PROJECT TITLE: Barelas Court Townhomes ZONE ATLAS/DRNG. FILE #: K-14 / 1042

**DRAINAGE REPORT  
FOR  
BARELAS COURT TOWNHOMES**

RE: REVISED DRAINAGE PLAN/REPORT SUBMITTAL OF BARELAS COURT  
TOWNHOUSES (K-14/D42) REVISION DATED MARCH 13, 1989 RECEIVED  
MARCH 14, 1989

RE: BARELAS COURT TOWNHOMES.  
PROJECT 3683.  
REQUEST FOR APPROVAL OF AMENDED GRADING PLAN.

BARELAS COURT  
UNIT #9 - DRAINAGE

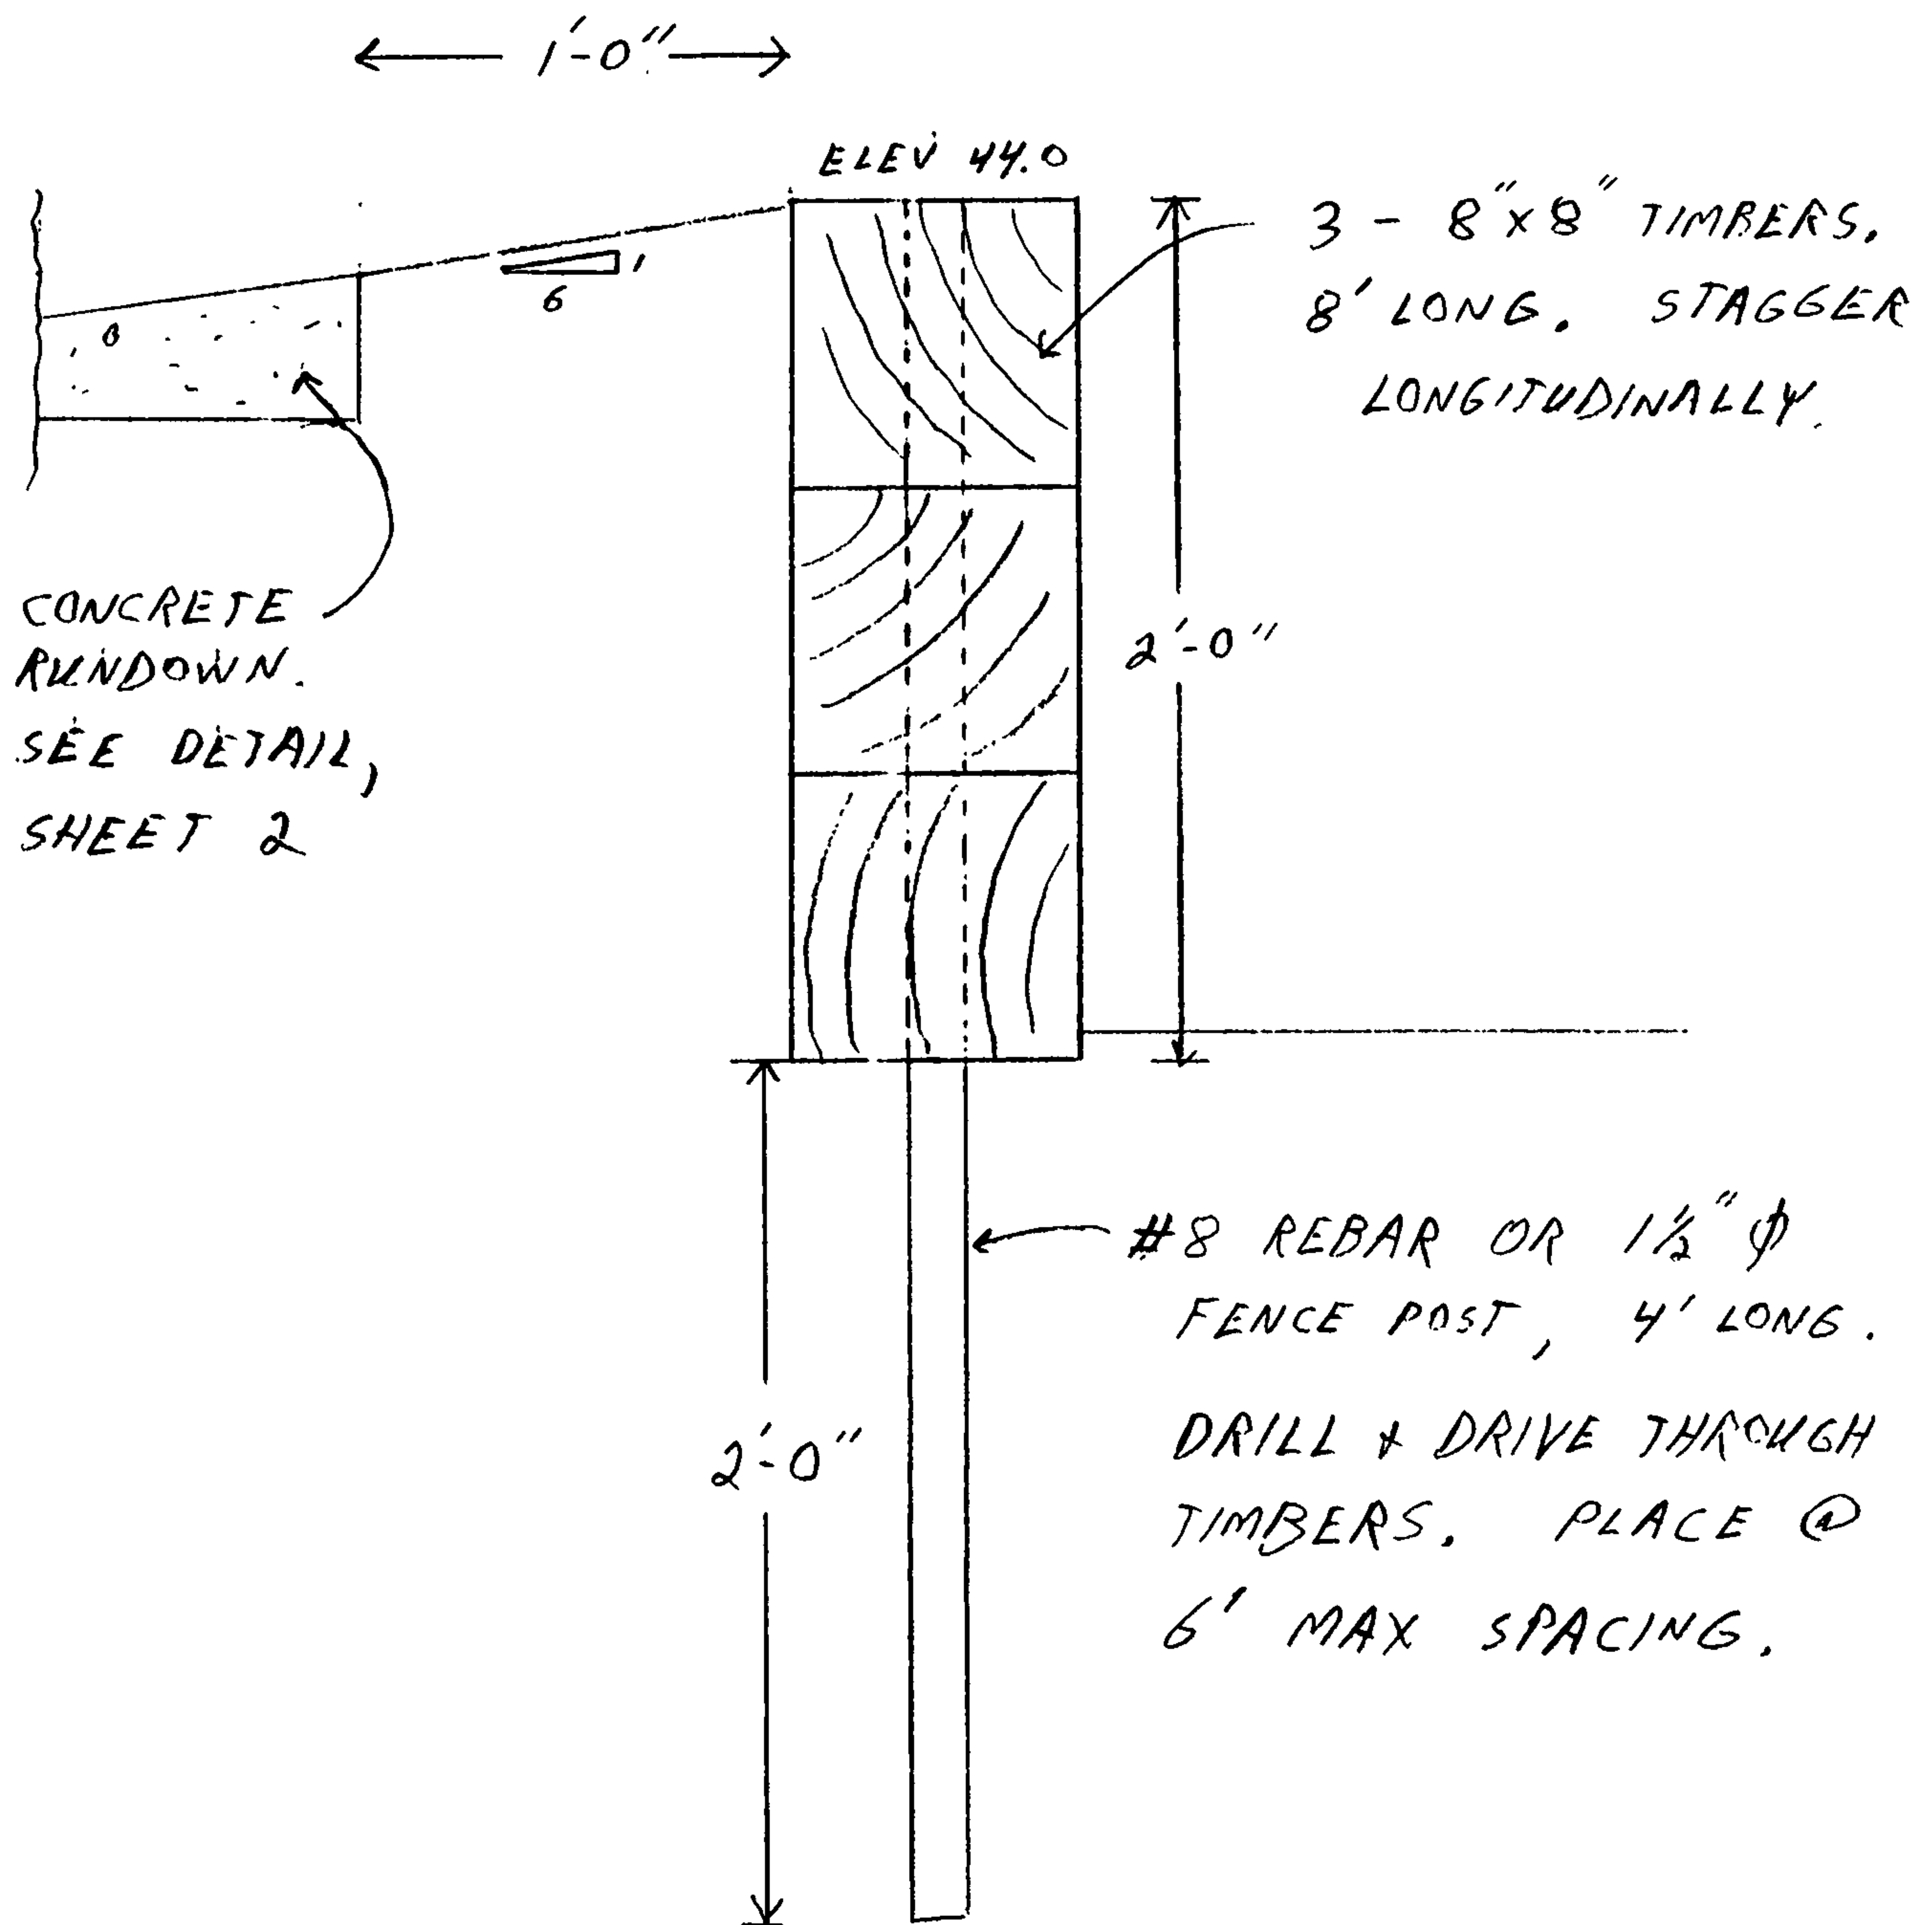
Remove Existing  
Driveway & Construct  
Curb & Gutter &  
Sidewalk, Match  
Grade w/ Existing  
Sidewalk And C&G

Remove Existing  
Sidewalk And C&G.  
Construct New  
Valley Gutter

BARELAS COURT  
DRAINAGE  
UNITS 1, 2, + 3

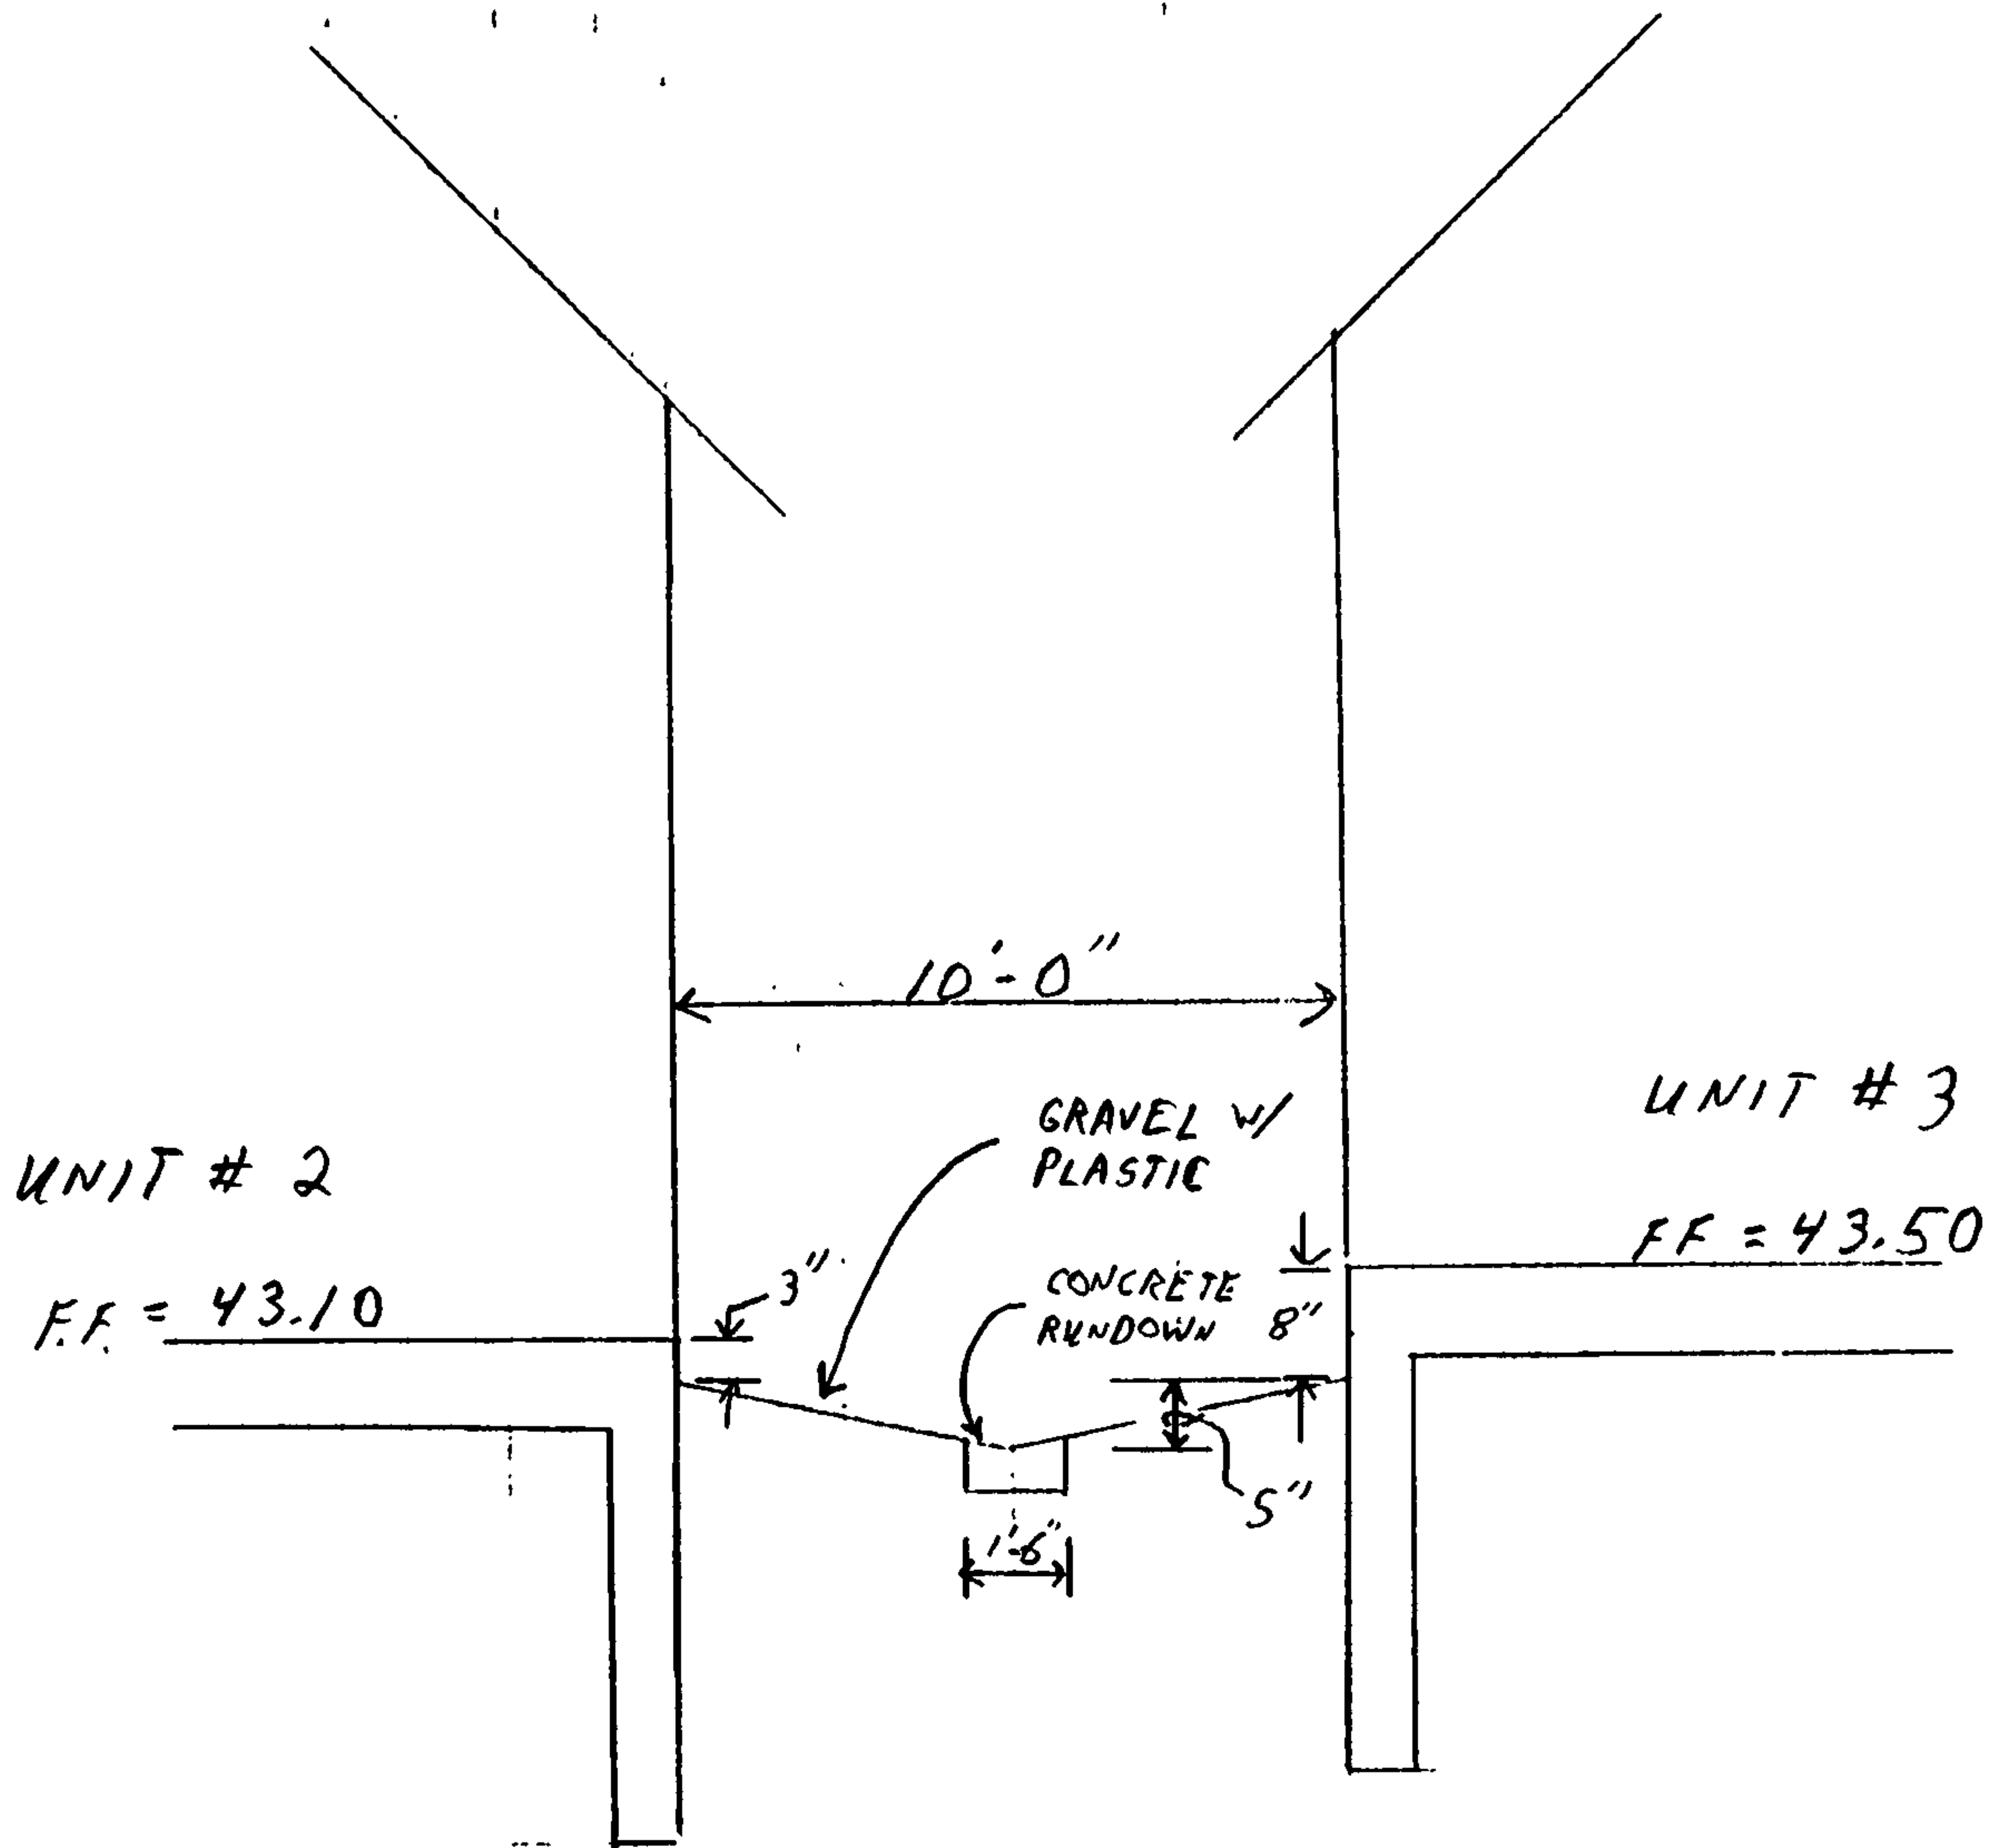
CONSTRUCT 12" WIDE  
SIDEWALK CULVERT.  
COA. DWG 2236

Construct 18" Wide x  
4' Long Sidewalk Culvert  
w/ Steel Top. See COA  
5th Drawing 2236
